200 David Dunlap Circle – Zoning By-law Amendment, Plan of Subdivision and Site Plan Control Applications – Request for Direction Report

Date:	April 2, 2014
To:	North York Community Council
From:	Director, Community Planning, North York District
Wards:	Ward 34 – Don Valley East
Reference Numbers:	13 158583 NNY 34 OZ and 13 158593 NNY 34 SB

Attachment 2: Site Plan

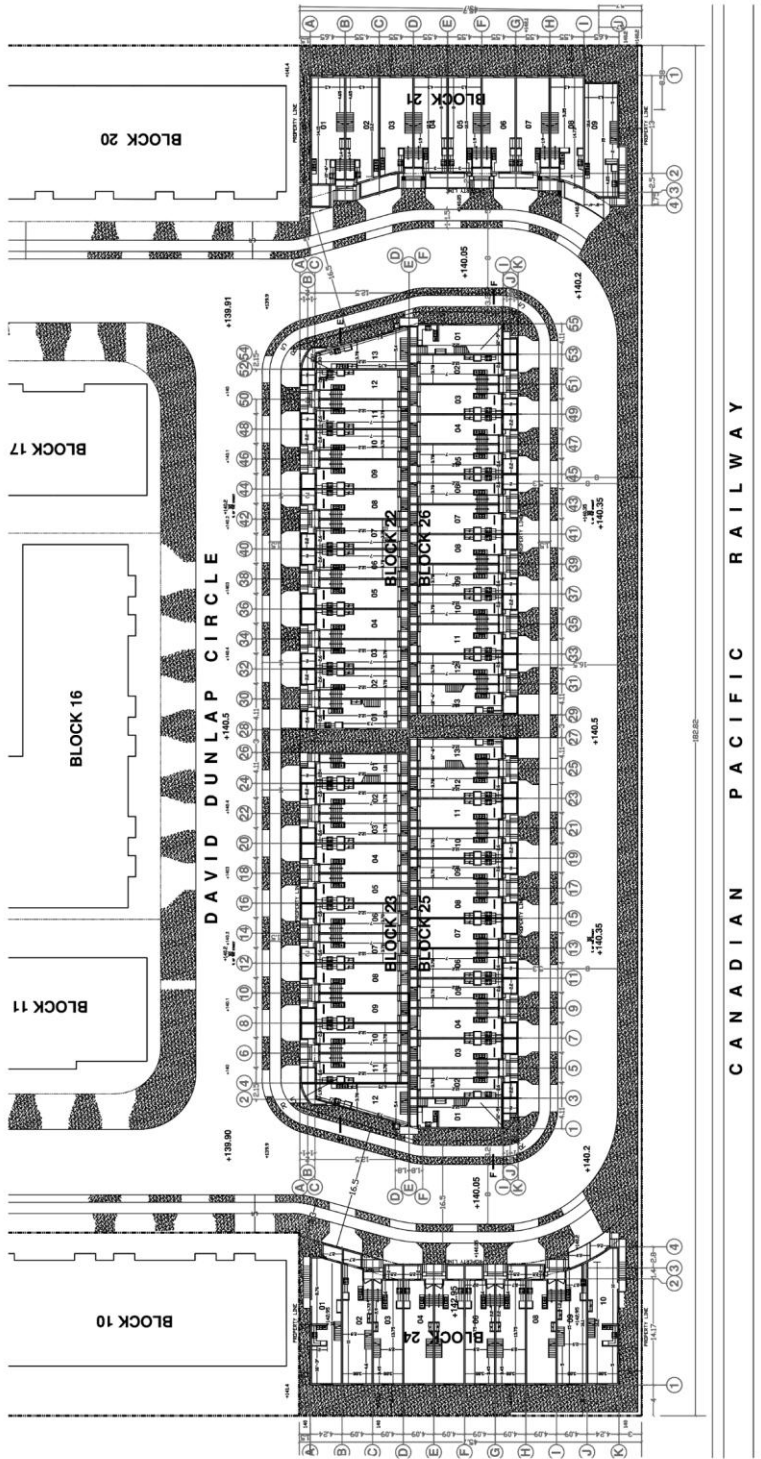
The townhouse units would be contained in six blocks (Blocks 21, 22, 23, 24, 25 and 26) configured around a new 16.5 metre public road that would connect to the existing 18.5 metre wide right-of-way network by way of extending David Dunlap Circle (see Attachment 2: Site Plan). All proposed townhouse units would front onto a public street with a proposed front yard setback of two metres. Landscaping is proposed on the adjacent public right-of-ways.

The proposed parking arrangement in the new development is similar to the adjacent townhouse development, with multiple curb cuts for front yard parking and front integral garages. However, the proposed 16.5 metre wide right-of-way, as opposed the 18.5 metre right-of-way abutting the site, further reduces the space available for sidewalks, landscaping, street trees and snow storage within the boulevard. The compounding impacts of the proposed multiple curb cuts and driveways, reduced front yard setbacks, narrower unit width and narrower boulevard width would result in streetscape conditions within the new development that do not solve the problems found in the existing adjacent neighbourhood. To ensure that adequate space is provided to accommodate the elements of a public street as described in Public Realm Policy 3.1.1.14 (e) of the Official Plan, the north-south sections of the U-shaped right-of way, where the proposed townhouse units have front and side building relationships to the street, should be widened to a width of 18.5 metres. An 18.5 metre right-of-way for these portions of the street would extend the pattern of the existing local streets into the new development, and be more consistent with the Official Plan and Infill Townhouse Guidelines, as well as the overall garden city character of Don Mills by providing more space for landscaping and street trees. Adjacent to the rail corridor, where a second sidewalk is not needed, a narrower right-of-way width of 16.5 metre may be appropriate.

The proposed north-south portions of the U-shaped right-of-way in their current form do not extend the existing street alignment of David Dunlap Circle. A slight curve is proposed in the north-south segments of the street, resulting in lots that are smaller than the adjacent townhouse development. However, on these smaller lots, similar sized townhouses to the adjacent townhouse development are proposed. The outcome is that the proposed townhouse units that have reduced front and rear yard setbacks. The townhouses on Blocks 21 and 24 are pushed further east and west resulting in rear yards for these townhouse units that do not provide appropriate outdoor rear amenity space. Furthermore, the proposed road configuration results in a loss of sightlines and clarity of street connection into the new development from the existing neighbourhood. Townhouses with front integral garages would protrude into the view terminus of the existing neighbourhood street and hide the extended streets for pedestrians and vehicles. To meet the intent of the Policies of Official Plan and the Infill Townhouse Guidelines, the new public street should be realigned to remove the curve in order to create

The application proposes front yard setbacks of two metres, and is also proposing exemptions for projections be permitted into this setback. These amendments substantially reduce the opportunities for front yard landscaping, including street trees for these units. To help achieve the Official Plan Policies the Infill Townhouse Guidelines ask that units with front integral garages should provide a minimum six metre setback from the front property line to provide adequate space for street trees and front yard landscaping in addition to the driveway. As mentioned above, residents of the adjacent townhouse development have noted that there is a lack of space within the boulevard and their front yards for snow storage and landscaping due to the number of driveways, narrow unit widths, and shallow front yard setbacks within their development. This condition identified by the adjacent residents confirms the need for larger front yard building setbacks, as opposed to shallower setbacks as proposed in this development.

To be consistent with the Official Plan Policies, the garden city character of Don Mills and the principles of the Infill Townhouse Guidelines, the proposed townhouse development front yard setbacks should be increased to six metres. Encroachments within that six metre front yard setback should be minimized to provide space for landscaping, street trees and snow storage. A setback of two metres is the minimum size that may be appropriate, if parking for the townhouse units is provided in a different manner, either at the rear of the townhouse units or in an underground shared garage.

The proposed townhouse units with front integral garages have narrow unit widths of 4.0 to 4.24 metres wide and the high percentage of frontage devoted to curb cuts and driveways, resulting in a streetscape that would be dominated by vehicles. These conditions along with the proposed two metre front yard setbacks and the exemption for building projections to be permitted within the required setback will not provide enough space for soft landscaping or street trees. Whether these townhouses are conventional or back-to-back units if their frontages are proposed to be less than six metre wide, parking for these units should be removed from the street frontage. If the applicant continues to pursue units with widths below six metres, parking should either be provided in an underground shared garage or at the rear of conventional townhouses. Alternative organizations of the townhouses to solve parking access and streetscape issues could also be designed to include opportunities to help to reduce the number of units facing the rail corridor. The potential noise, dirt and visual problems associated with the rail corridor make these poor facing conditions for the townhouse units. Opportunities to reorganize some units to not face onto the rail corridor could therefore improve this relationship.

Due to its length and width, a mid-block pedestrian walkway should be provided through the back-to-back townhouse block to provide a pedestrian connection between the public sidewalks on David Dunlap Circle and the new public street. The proposed three metre building separation between townhouse Blocks 22 and 23 and Blocks 25 and 26 is the appropriate location and width for a mid-block pedestrian walkway. However, this building separation is misaligned and is also residual space that is simply an outcome to the layout of the townhouse blocks. This offset walkway configuration produces a number of sightline and safety concerns, if this space is to be used for pedestrian circulation between the buildings. Official Plan Policy 3.1.1.12 states that private open spaces shall be designed to promote pedestrian safety and security. A mid-block pedestrian walkway should be provided through the townhouse blocks and this should be a straight and direct route with clear sight lines between the townhouses blocks from the public sidewalks on David Dunlap Circle and the new public street.

The abutting townhouse development consists of conventional townhouses with individual private outdoor amenity areas in the rear yard of 5.5 metres. The proposed development recommends rear yard setbacks of four metres for townhouse Blocks 21 and 24 and zero metres for the proposed back-to-back townhouses within Blocks 22, 23, 25 and 26. The Infill Townhouse Guidelines ask for rear yard setbacks for grade related

The proposed rear yard setbacks, in combination with the proposed inappropriate front yard setbacks, will result in a further reduction of landscaped open space area for these new units. These reduced rear yard setbacks are not in keeping with the garden city character of Don Mills as intended by the Secondary Plan. They are also not in keeping with Official Plan Policy 3.1.2.5 (d) which states that new development will provide landscape open space within the development site. The proposed rear yards for townhouse Blocks 21 and 24 should be amended to 7.5 metres and additional at-grade landscape amenity should be provided for the back-to-back townhouses in order to meet the objectives of the Secondary Plan and the Official Plan. This could be accomplished by providing larger front yard setbacks for the back-to-back units and relocating the vehicles from the street frontage and into an underground shared garage. Alternatively, as mentioned above, more conventional townhouses with parking either located in the rear of the units with decks or in an underground shared garage and traditional backyards should be provided for these units.

Attachment 4: Draft Plan of Subdivision

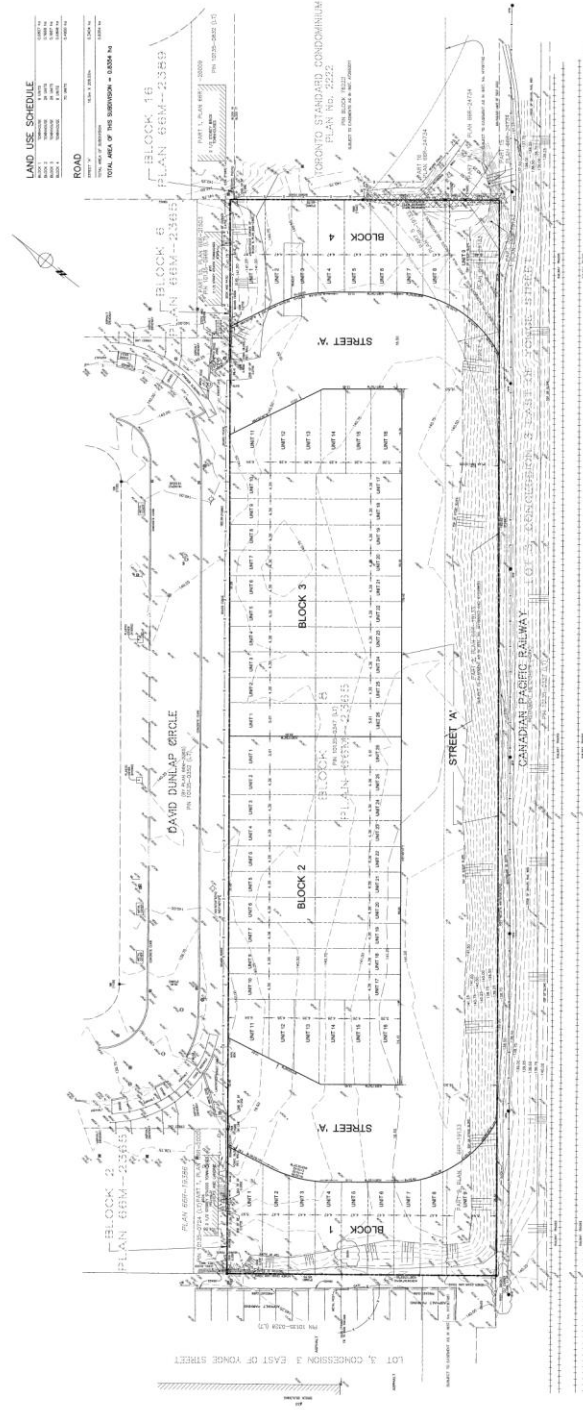
The proposed Draft Plan of Subdivision divides the site into four blocks and establishes lands to extend David Dunlap Circle into the site creating a 16.5 metre wide U-shaped right-of way to accommodate a new public road – Street 'A' (see Attachment 4: Draft Plan of Subdivision).

The applicant has amended the proposal since it was originally submitted but has not submitted an updated Draft Plan of Subdivision to reflect these changes. The current draft plan submitted as part of this application is not consistent with the latest proposal.
